WBS 3.0, C-0 Outfitting **Portion of the** **BTeV Project**

C-0 Outfitting
WBS 3.0
BTeV Project
Advanced Conceptual Design Report
April 2004

Stakeholder Input from Comment and Compliance Review

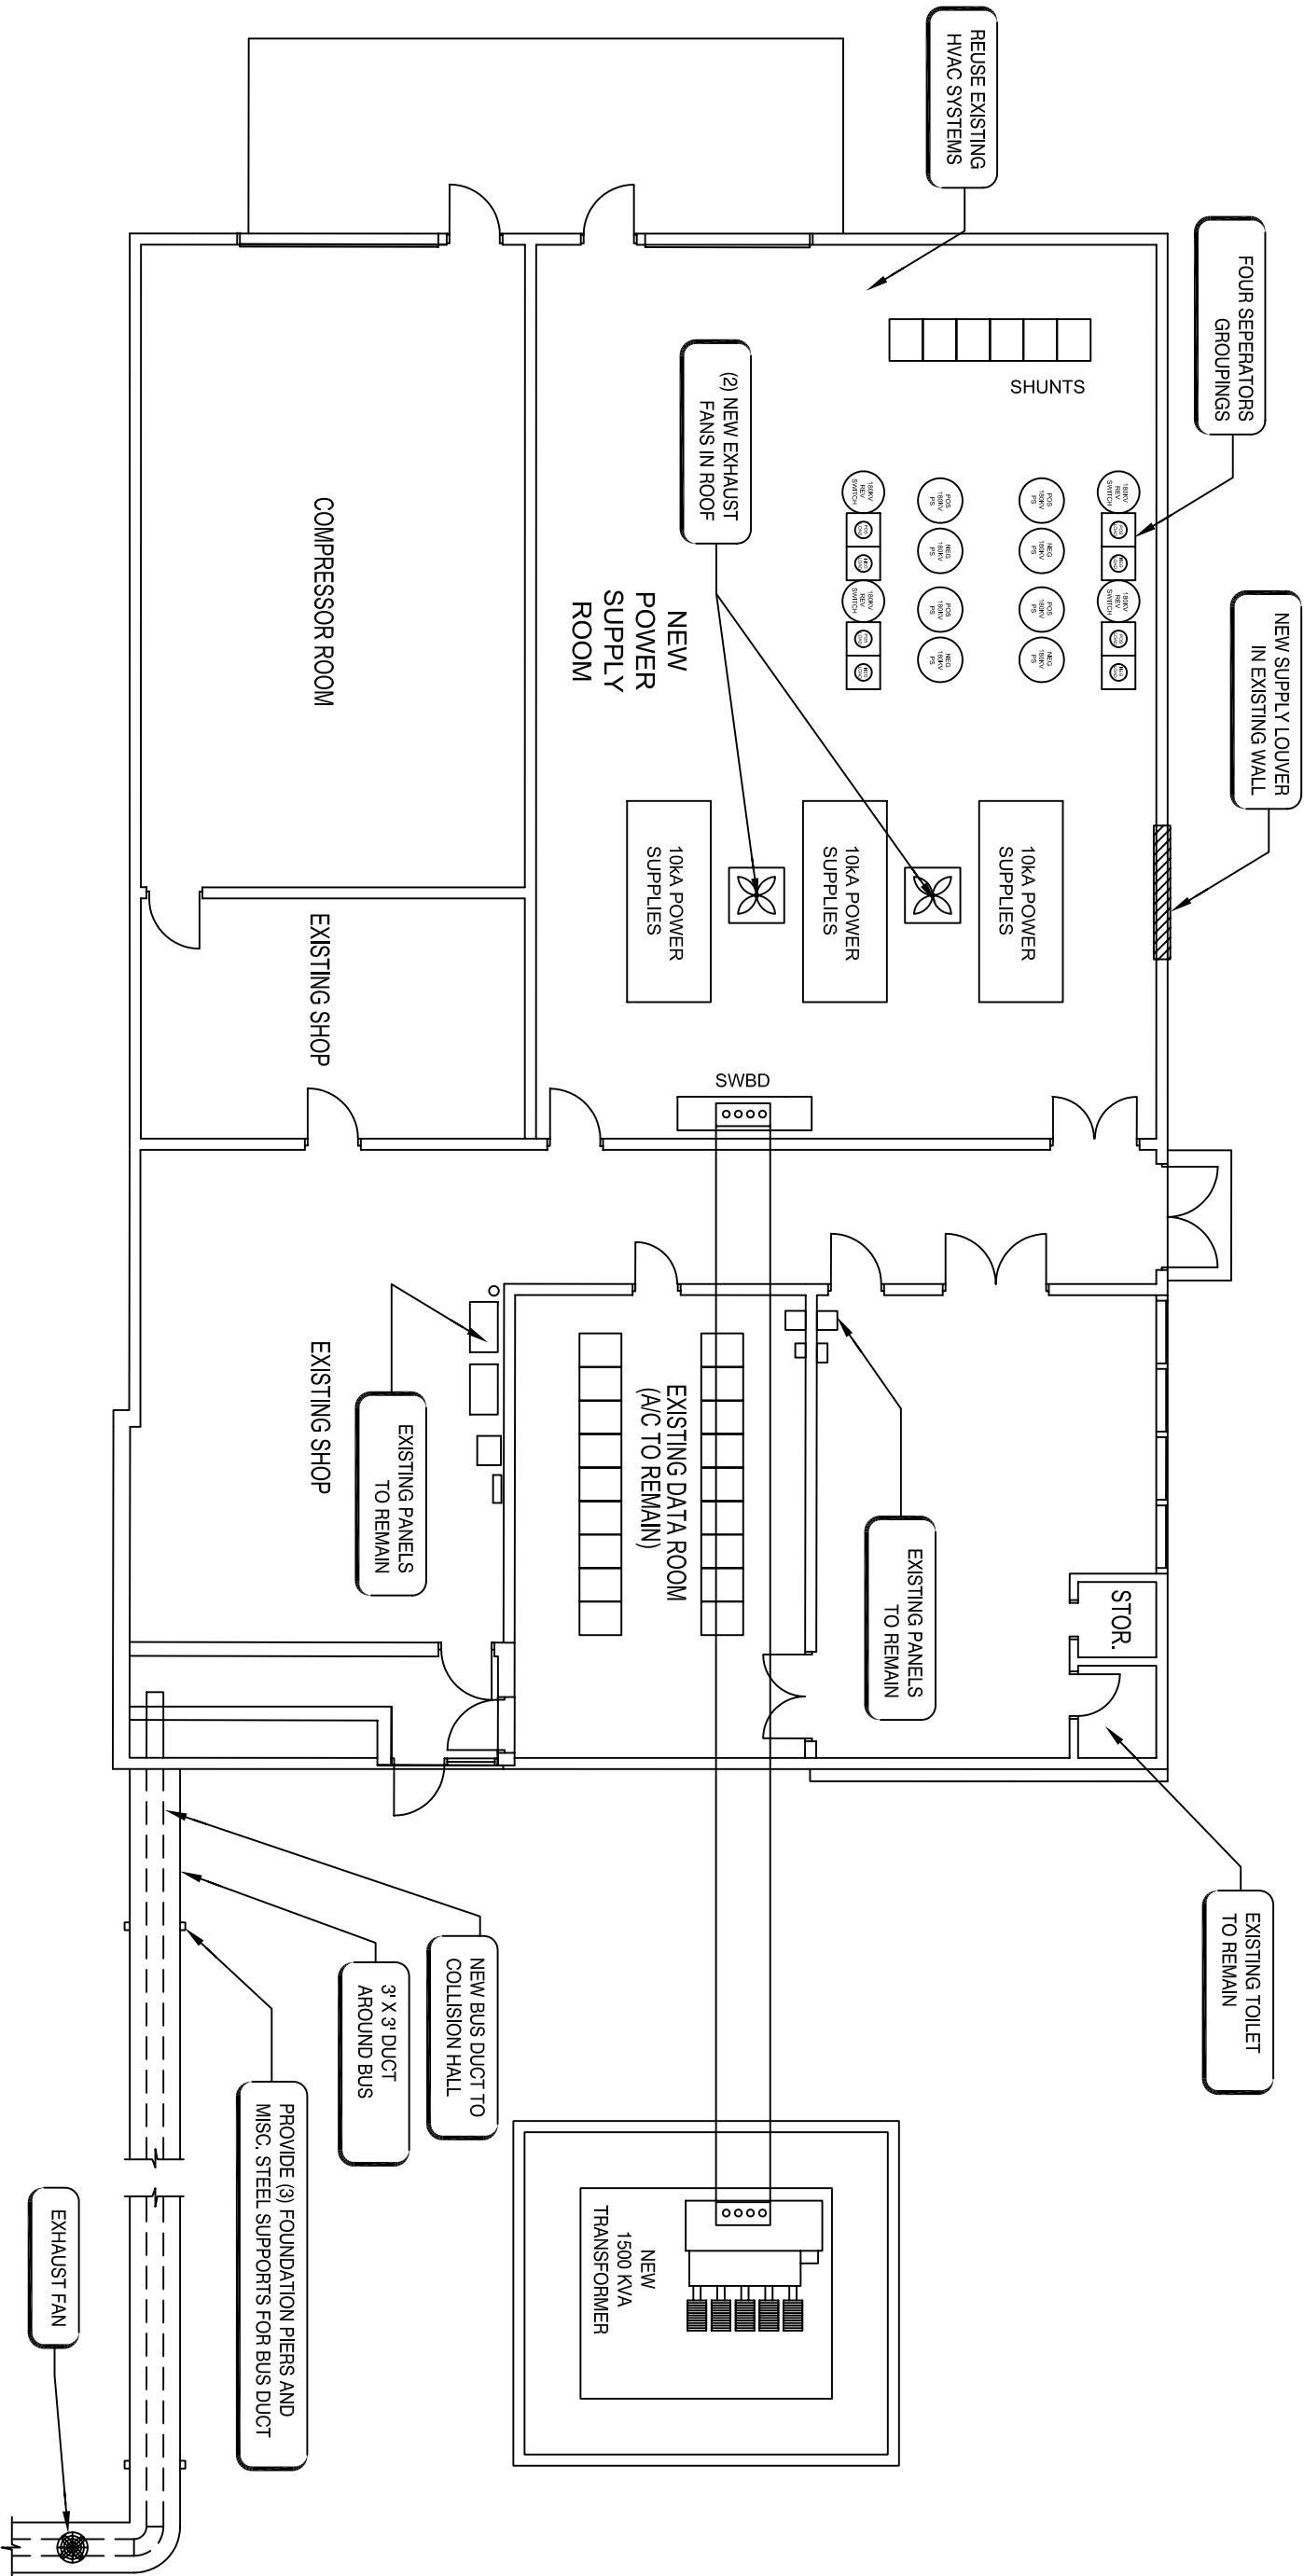
drawing A-12 - Need to show power supplies, reversing switches, and accessories for electrostatic separators in C0 Service Building. I asked George Krafczyk to provide this information.

FERMI NATIONAL ACCELERATOR LABORATORY	
UNITED STATES DEPARTMENT OF ENERGY	
C-0 OUTFITTING	
ELECTRICAL ONE-LINE DIAGRAM	
DRAWING NO.	6-8-3
CD-1 REVIEW	E-8
REV.

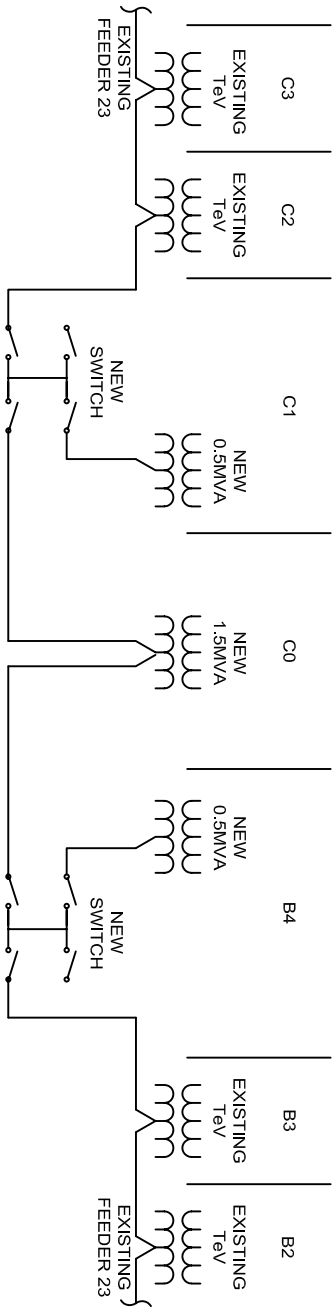
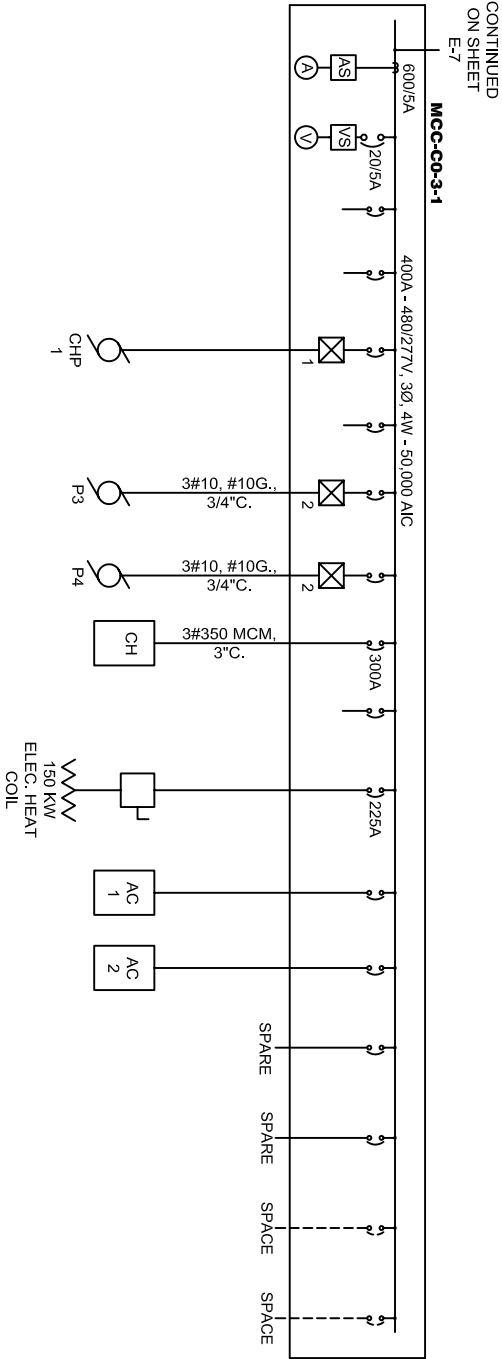
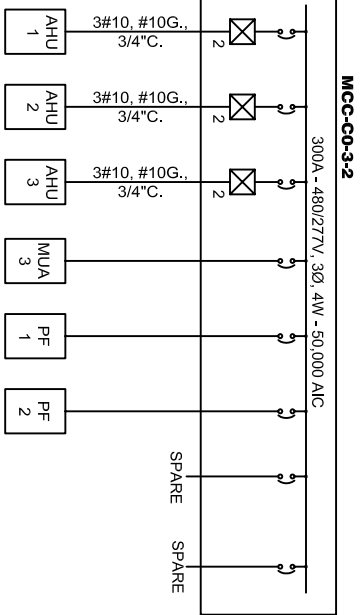
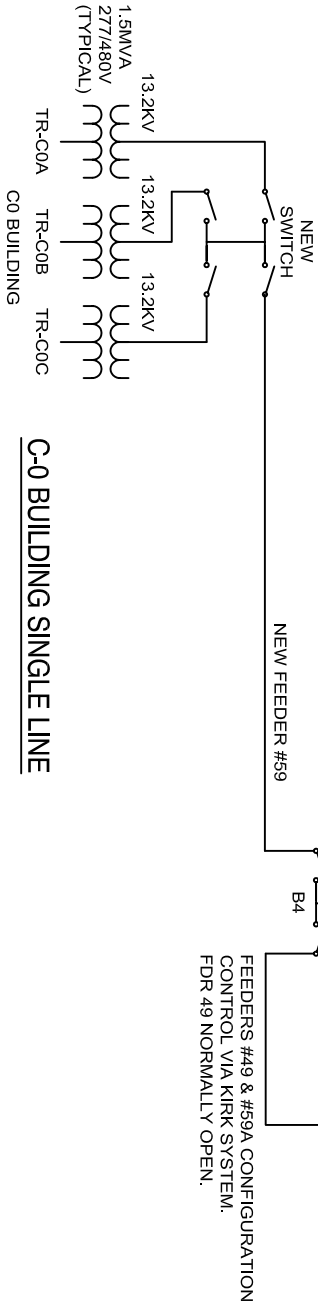
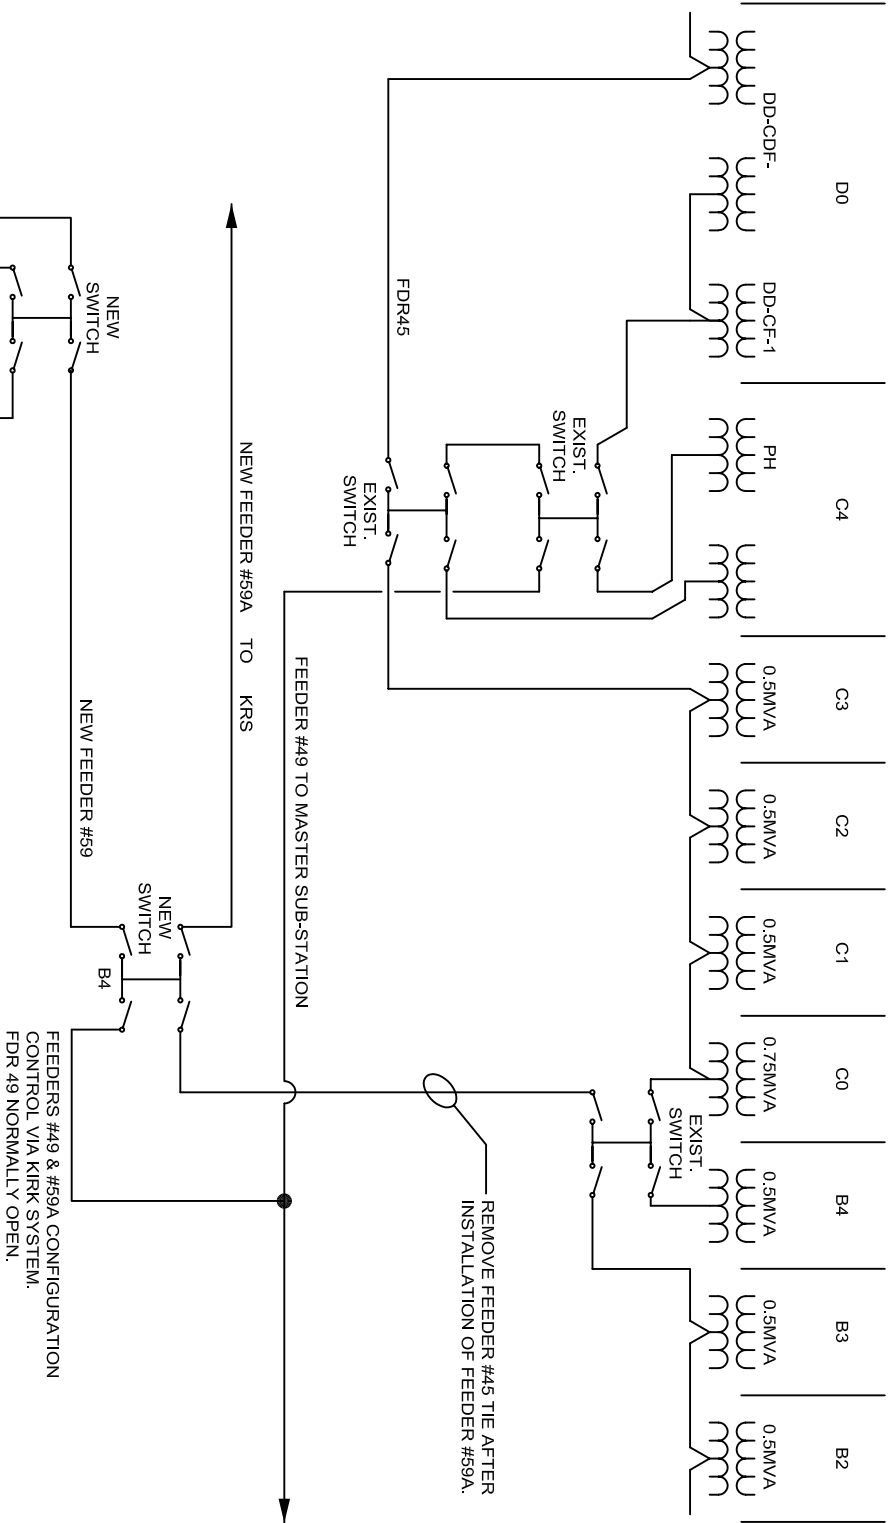
The one-line drawing shows two 75 KVA transformers that service the 1st floor counting room. If we look at page M-2 of drawing 6-8-3, we find 58 relay rack positions and a total power draw estimate of 132 kW. Division gives about 2kW per rack position; many relay racks already determined in the experiment have power draws in excess of this number. Further, the 132kW expected load is dangerously close to the 150kW of total AC available from the two transformers. We should probably allow for larger transformers - or a third 75KVA unit.

The space available as the drawing shows only allow for roughly 45 racks. We will verify that the supplied power is adequate for the rack electrical loads.
